Water Management Referral Response

Application Number:	DA2022/2152
Proposed Development:	Demolition works and subdivision of land into 9 lots including tree removal and infrastructure work
Date:	25/08/2023
To:	Adam Croft
Land to be developed (Address):	<p>Lot 3 DP 210342 , 128 Crescent Road NEWPORT NSW 2106</p> <p>Lot 21 DP 545339 , 57 The Avenue NEWPORT NSW 2106</p> <p>Lot LIC 407538 , 57 The Avenue NEWPORT NSW 2106</p> <p>Lot LIC 460612 , 57 The Avenue NEWPORT NSW 2106</p> <p>Lot 1 DP 503390 , 126 Crescent Road NEWPORT NSW 2106</p> <p>Lot 2 DP 210342 , 55 The Avenue NEWPORT NSW 2106</p> <p>Lot 111 DP 556902 , 122 Crescent Road NEWPORT NSW 2106</p> <p>Lot 112 DP 556902 , 122 Crescent Road NEWPORT NSW 2106</p> <p>Lot LIC 188424 , 122 Crescent Road NEWPORT NSW 2106</p> <p>Lot 295 DP 820302 , 122 Crescent Road NEWPORT NSW 2106</p> <p>Lot 295 DP 820302 , 122 Crescent Road NEWPORT NSW 2106</p>

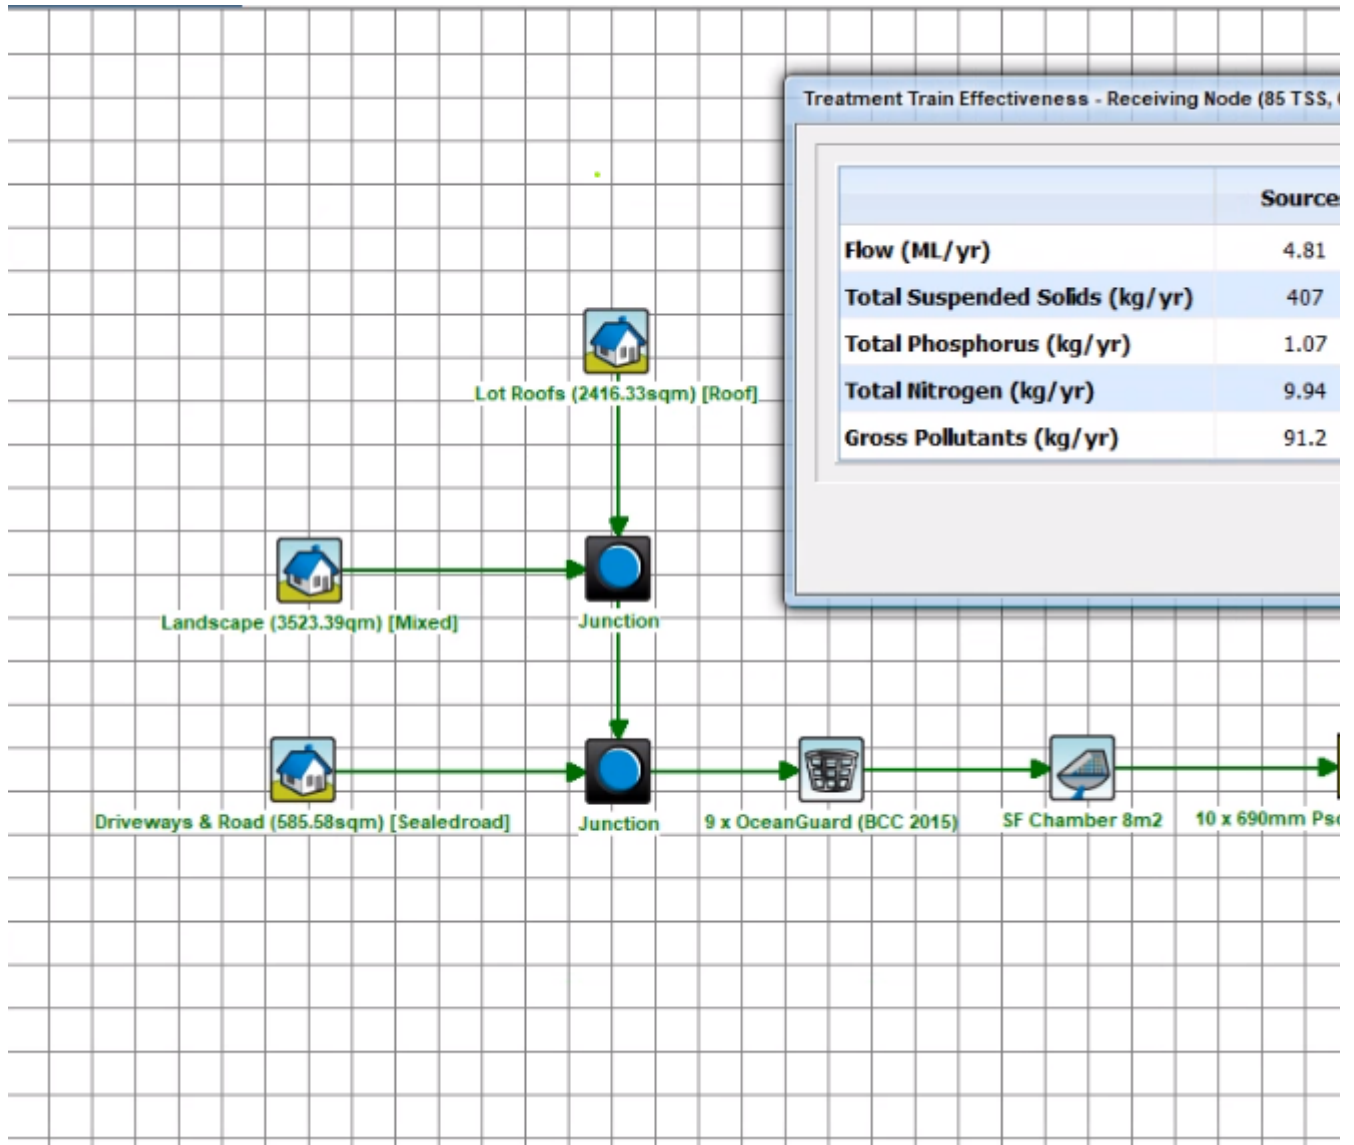
The supplied Music model is showing a non compliance with the total suspended solid TSS.

Vegetated system (vegetated swales or similar) should be developed for each property to increase the% reduction efficiency and comply with the Water Sensitive Urban Drainage requirements.

The proposal is therefore unsupported.
